LAND AT ASHFIELD FARM, KIRBY ROAD, DESFORD
THE FOOTPATH SCHEME
6 January 2025

ROAD SAFETY AUDIT RESPONSE REPORT

PROPOSED RESIDENTIAL DEVELOPMENT
LAND NORTH OF KIRKBY ROAD, DESFORD

Road Safety Audit Stage 1 Addendum

ADC1969-DR-008-P3

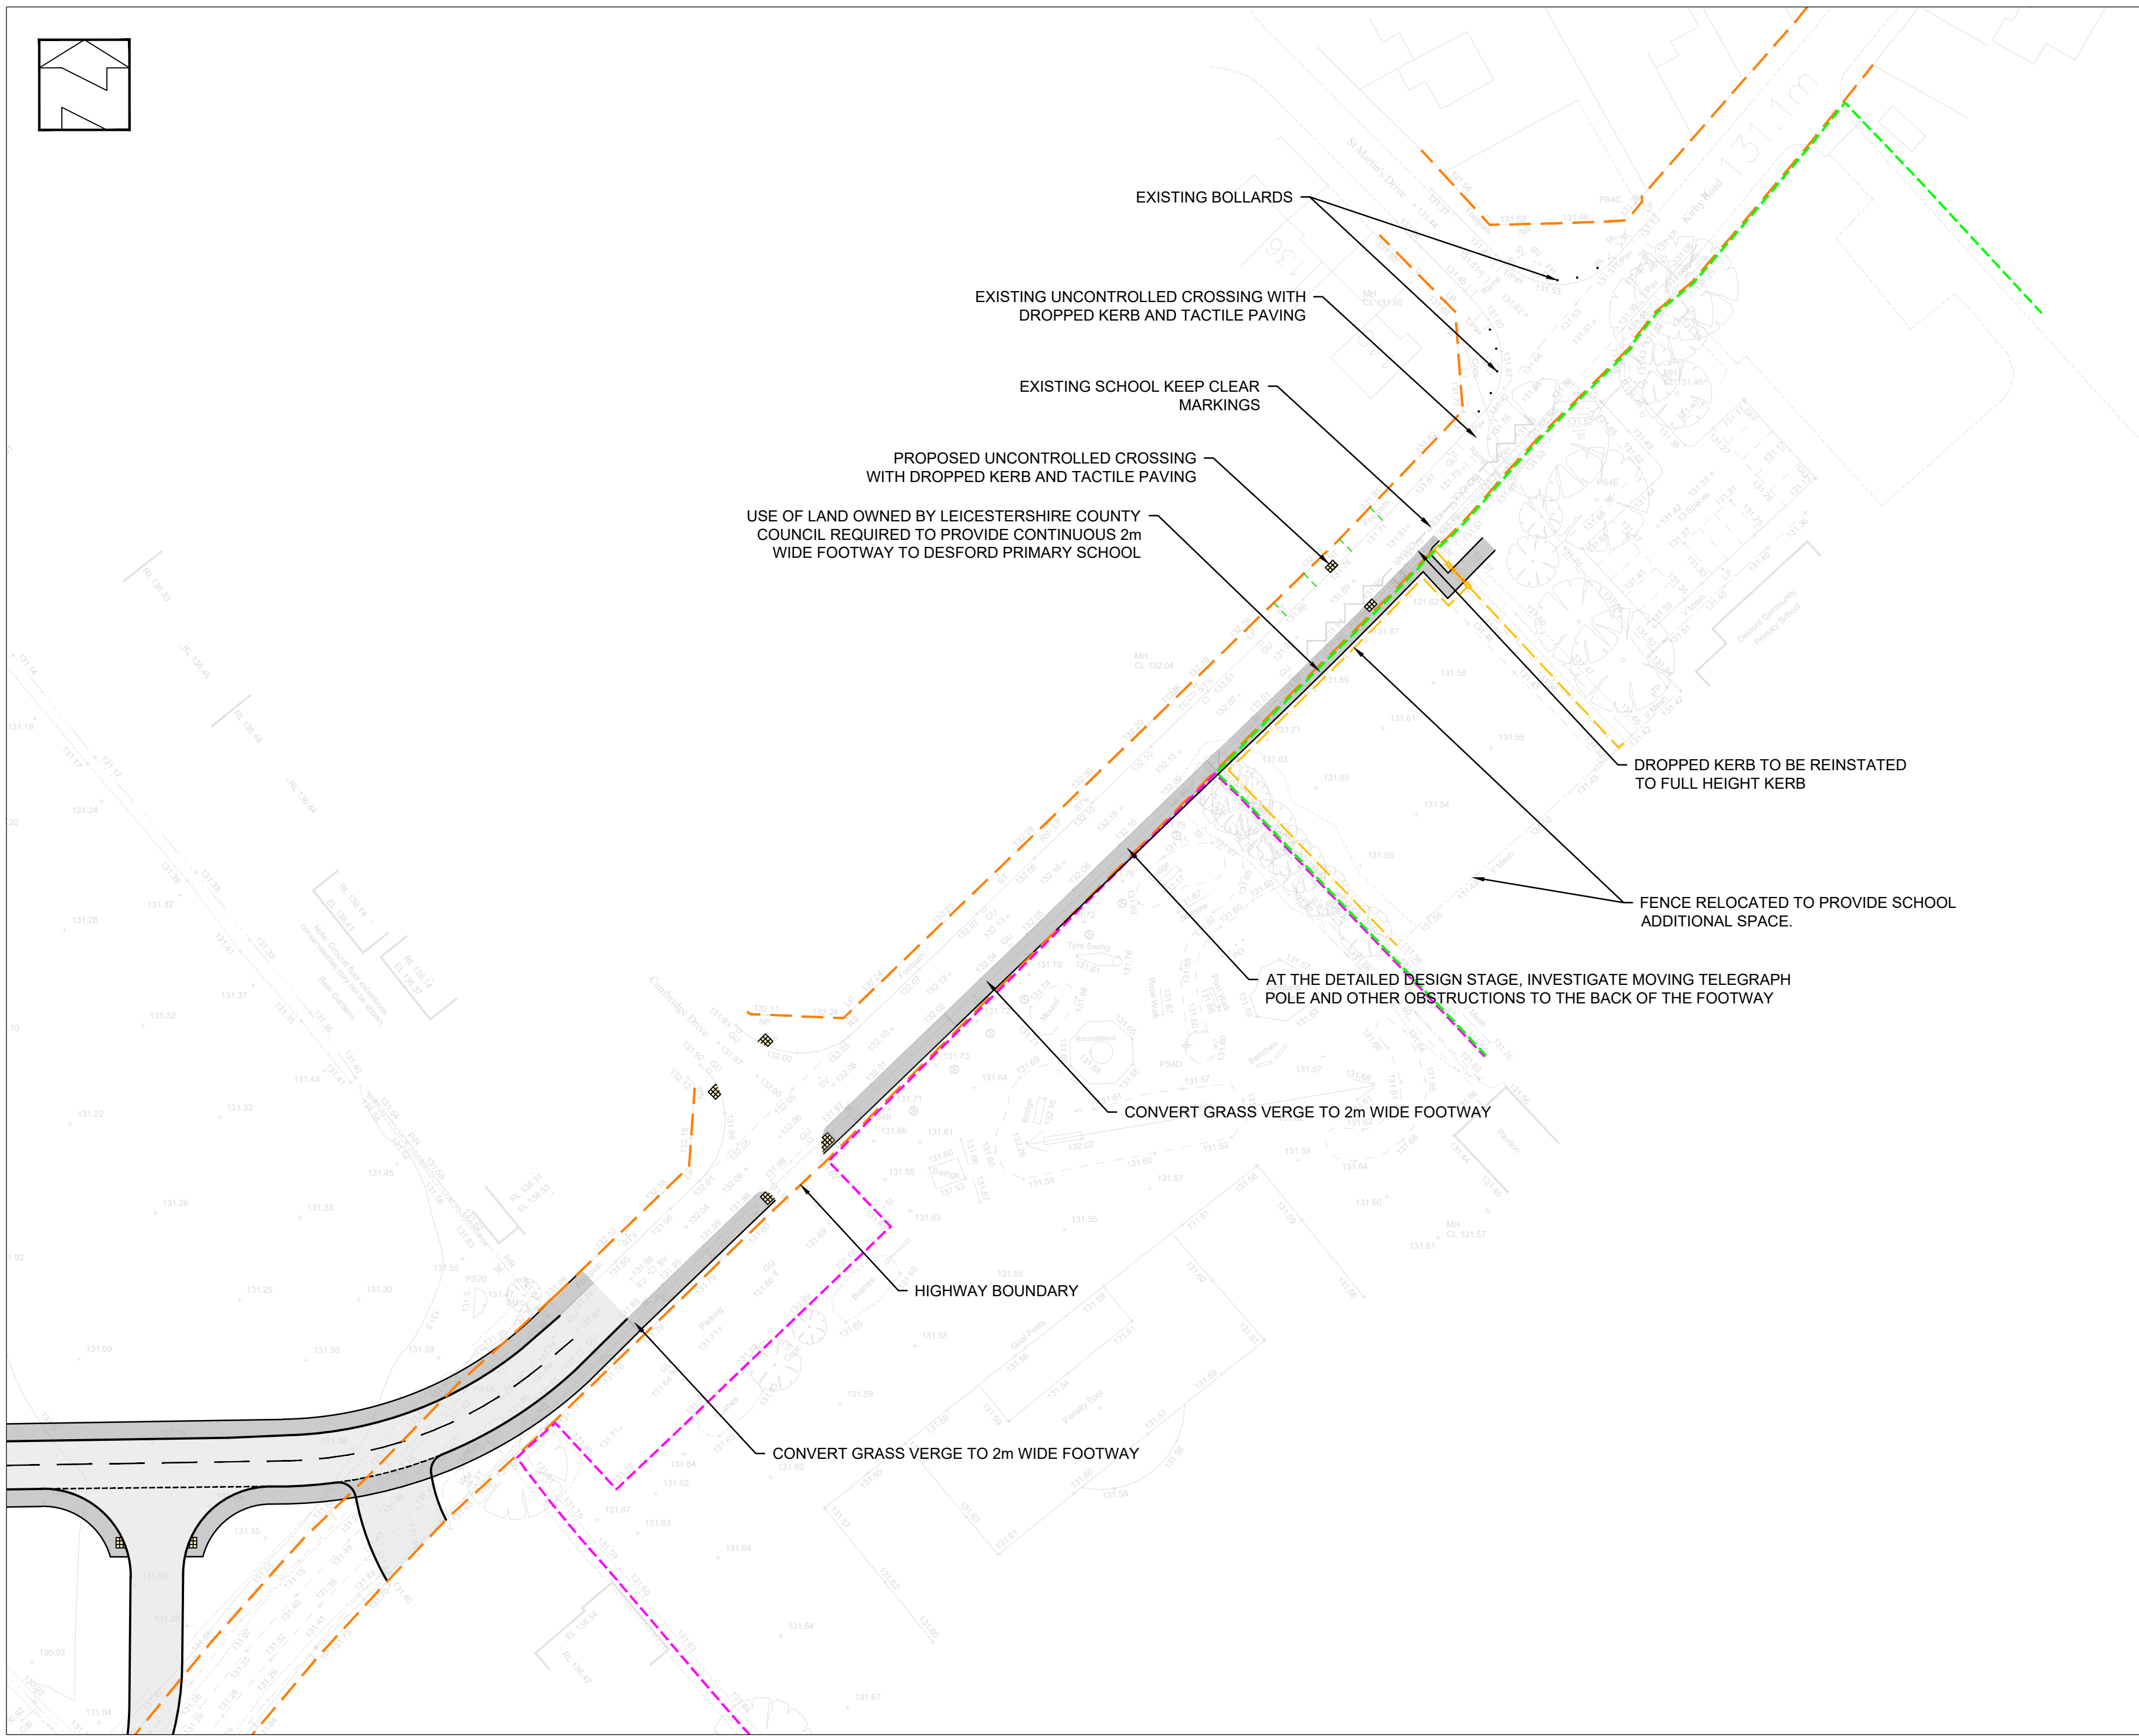
problem/issue		Design Organisation Response	Overseeing Organisation response	Agreed RSA Action
A-01	PROBLEM	Agree. A label has been added to the drawing to act as an additional prompt to the detailed designers.		
	Location: Kirkby Road – Along the footway			
	Summary: Cross Section – Existing obstruction in the verge may increase the risk of collisions involving pedestrians.			
	A new footway is proposed in the existing verge to the south of Kirkby Road. However, there are a number of obstructions in this verge including telegraph poles, signs and bins that may narrow the footway. This may be a particular concern at busier times around the start and end of the school day for pedestrians that rely on mobility aids such as mobility scooters and double width prams as well as when cyclists (unlawfully) using the footway. This may increase the risk of pedestrians stepping into the main carriageway to pass another pedestrian at the constraints created by the obstructions. These existing obstructions in the verge may increase the risk of collisions involving pedestrians.

RECOMMENDATION			
	It is recommended that clear widths are investigated at the next stage of design and, where necessary and practicable, obstructions are either relocated to the back of the footway or marginal widening to the rear of the footway is provided.			
A-02	PROBLEM	Agree. A dropped kerb has been added to the footway on the southern side of Kirkby Road.		
	Location: Kirkby Road – Eastern end of the footway.			
	Summary: Specific Road Users – Lack of crossing facility may increase the risk of collisions involving users who rely on mobility aids.			
	There is an onwards desire line to the eastern end of the proposed footway. However, this has no provision for users who rely on mobility aids, specifically those users with prams, wheelchairs or mobility scooters. The alternatives for these users may require them to use drop kerbs provided for the nearby car park access to cross where there is no other provision on the northern side of the road consequentially increasing the risk of these users being trapped in the carriageway. This lack of dropped crossings on desire lines may increase the risk of collisions involving users with mobility issues.

RECOMMENDATION			
	It is recommended that a dropped kerb is provided to the eastern end of the footway to facilitate safe transition between the footway and carriageway to driveways opposite. The audit team note that driveways would preclude the provision of a full tactile dropped crossing here.

P3	20.12.24	Updated following RSA	MT	DC
P2	18.12.24	Updated school access	MT	DC
P1	13.11.23	First issue	MT	DC
Rev	Date	Description	Dr	Rev
